Product Change Notification: MAAN-12RYA0996

CCB 6690 Final Notice: Qualification of MPHL as a new final test site for selected AT89Cxx, AT89LPxx, AT89S8253, ATMEGA16xx, ATMEGA32, ATMEGA48, ATMEGA6xx, ATMEGA8xx, ATTINY2xx, ATTINY4313 and ATTINY861A device families available in 20L PDIP (.300in), 28L SPDIP (.300in) and 40L PDIP (.600in) packages.

PCN Status:Final Notification

PCN Type:Manufacturing Change

Pre and Post Change Summary

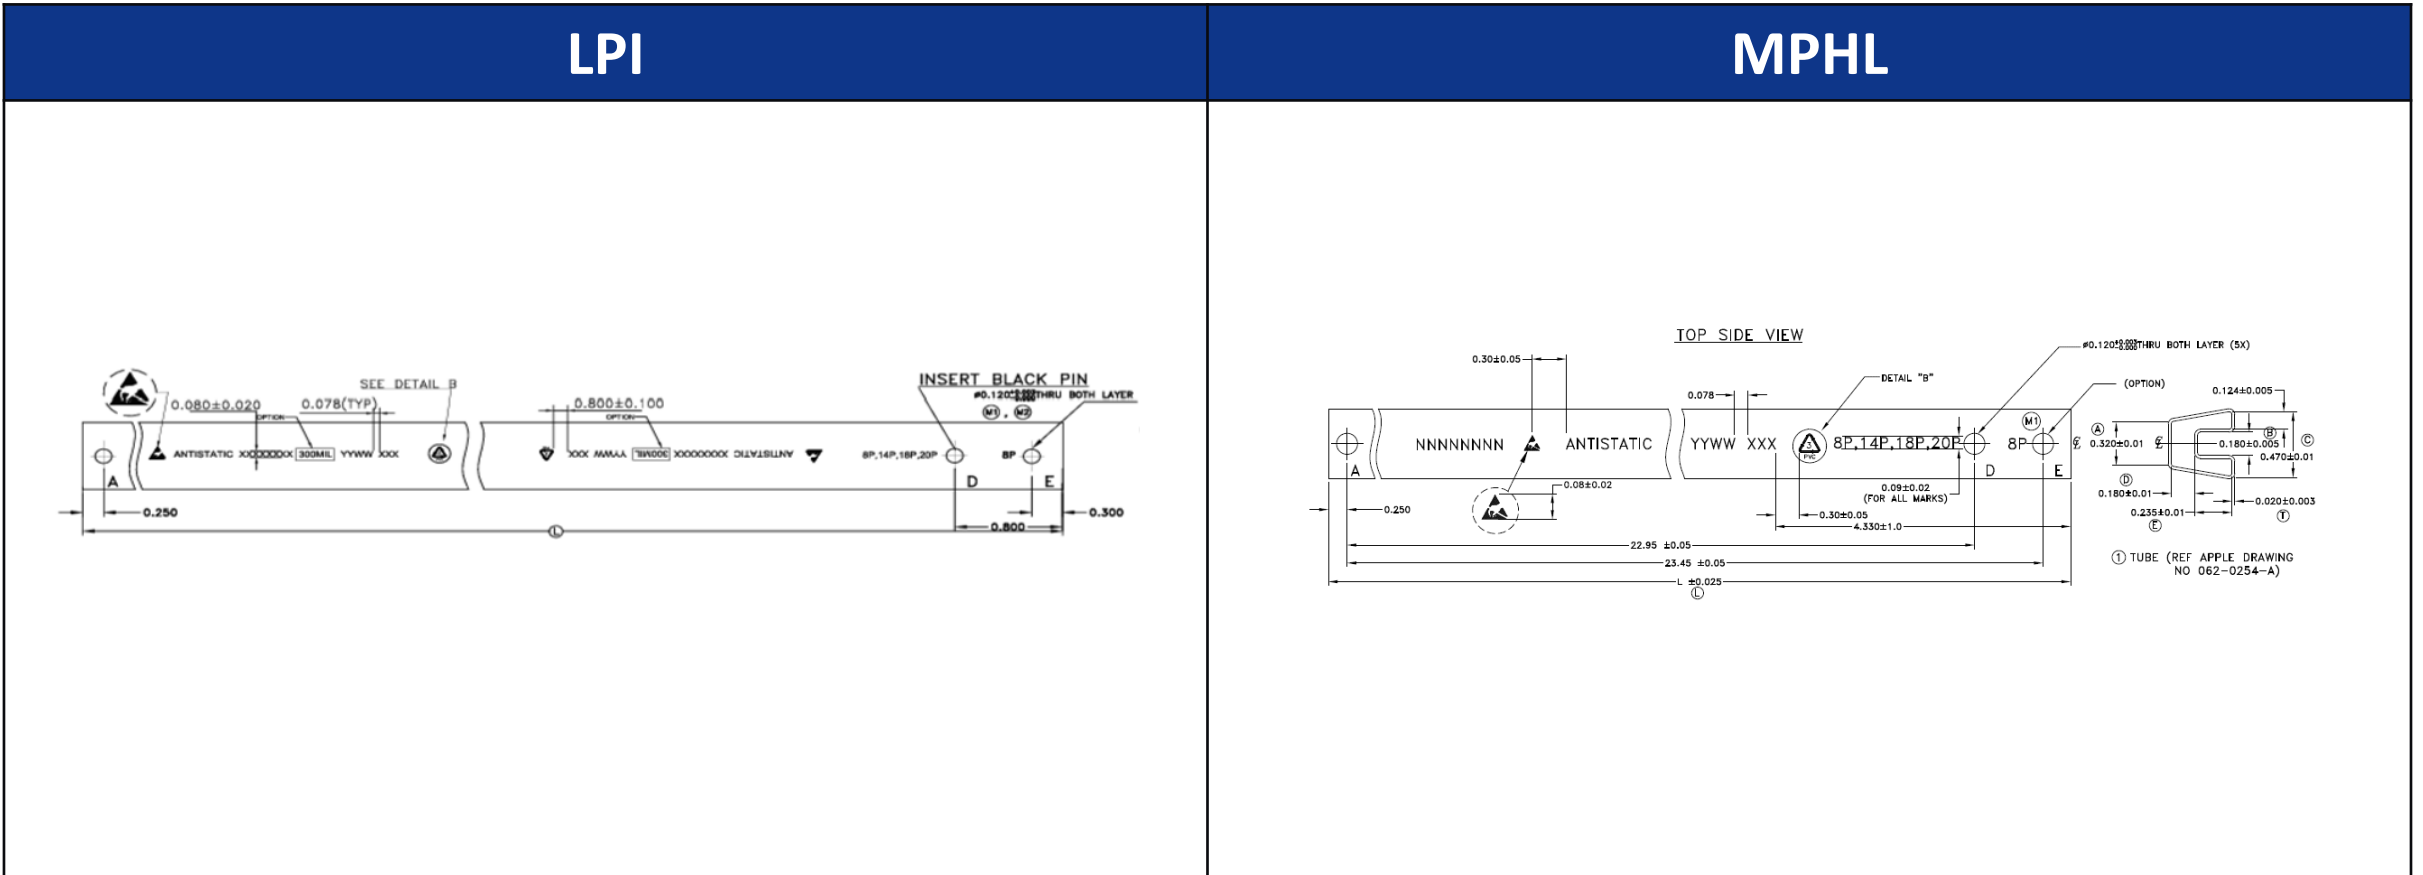
Plant	LPI	MPHL
Base Quantity Multiple (BQM)	18	18
Pin1 Orientation	Pin# 1 Toward Green stopper or pin	Pin# 1 Toward Green/White stopper or pin

Plant	LPI	MPHL
Base Quantity Multiple (BQM)	14	14
Pin1 Orientation	Pin# 1 Toward Green stopper or pin	Pin# 1 Toward Green stopper or pin

Plant	LPI	MPHL
Base Quantity Multiple (BQM)	10	10
Pin1 Orientation	Pin# 1 Toward Green stopper or pin	Pin# 1 Toward Green stopper or pin

Pre and Post Change Summary – 28L Tube

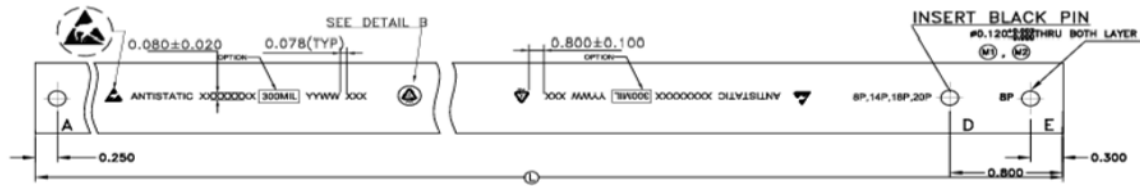
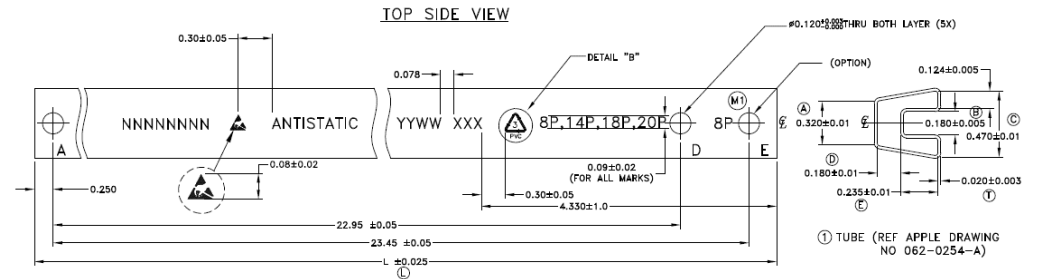
Plant	Color	Length (in)	Width (in)
LPI	Clear	20.33	0.47 +/- 0.01
MPHL	Clear	24 +/- 0.025	0.47 +/- 0.01

Pre and Post Change Summary – 40L Tube

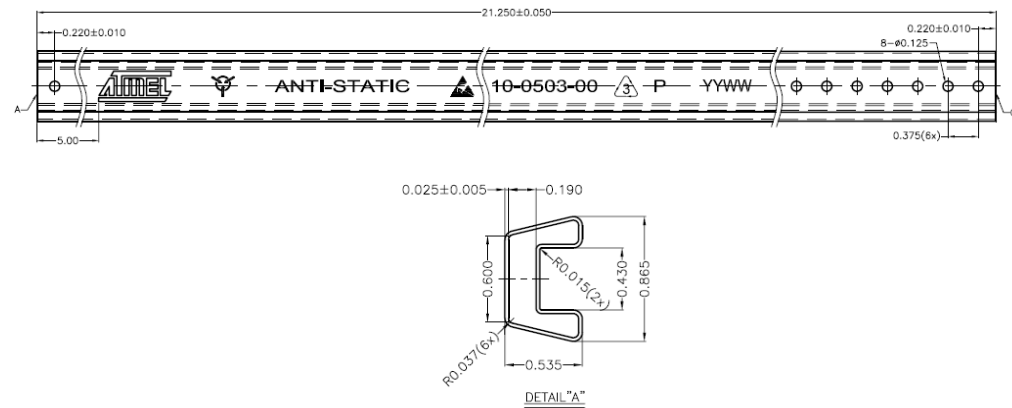
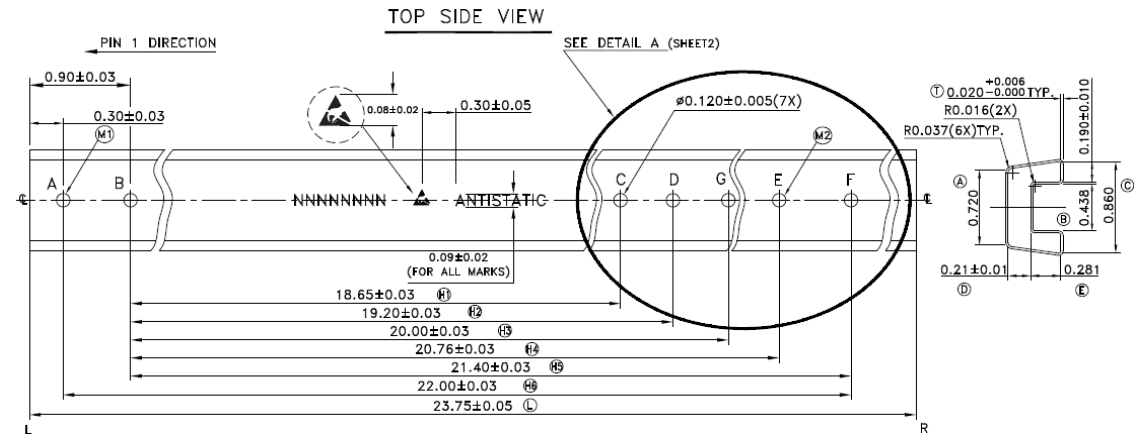
Plant	Color	Length (in)	Width (in)
LPI	Clear	21.25	0.865
MPHL	Clear	23.75 +/- 0.05	0.860
